## Technical Information Bulletin

### E249

PACCAR MX-11 EMY17 and 18 Groove worn into EGR Cooler at Coolant Pipe Connection

Figure 3 Improved coolant pipe installation

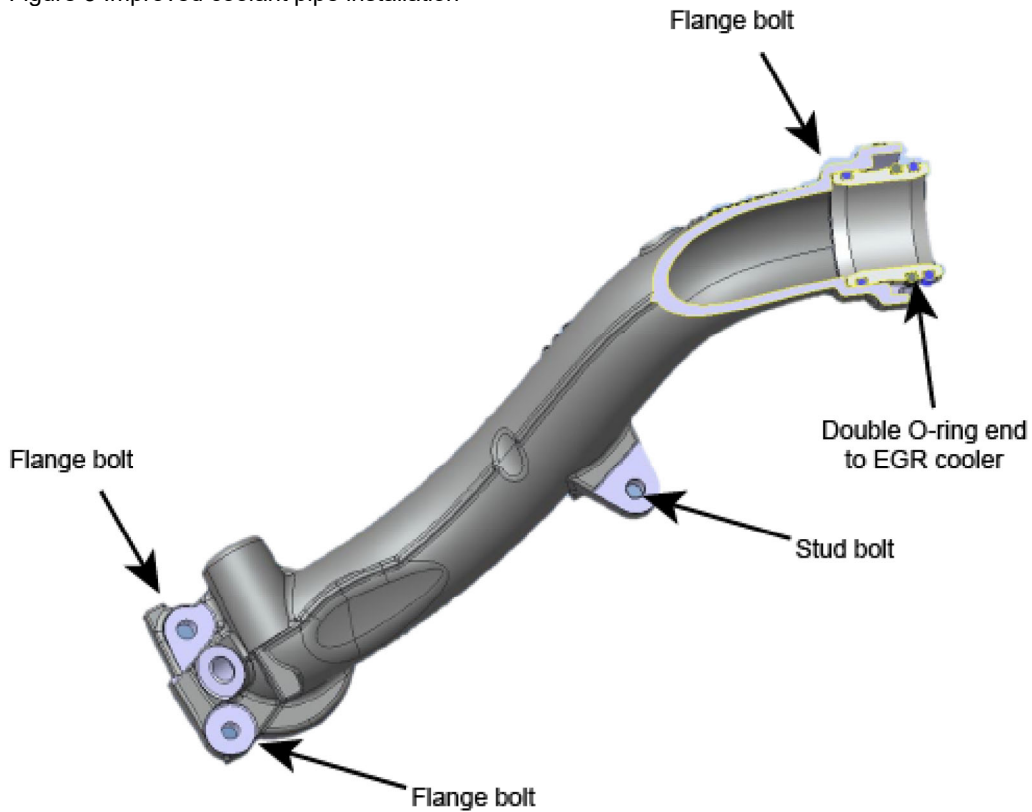
2. If the leak is verified at this point, replace the coolant pipe. The EGR cooler may have a groove worn into it as shown below. The coolant pipe has been updated with an improved seal at the EGR cooler that seals on either side of the groove. Additional bolts and a stud are included with the new parts (not noted in RMI, but are noted in Parts Online). See the figure below for bolt and stud locations.
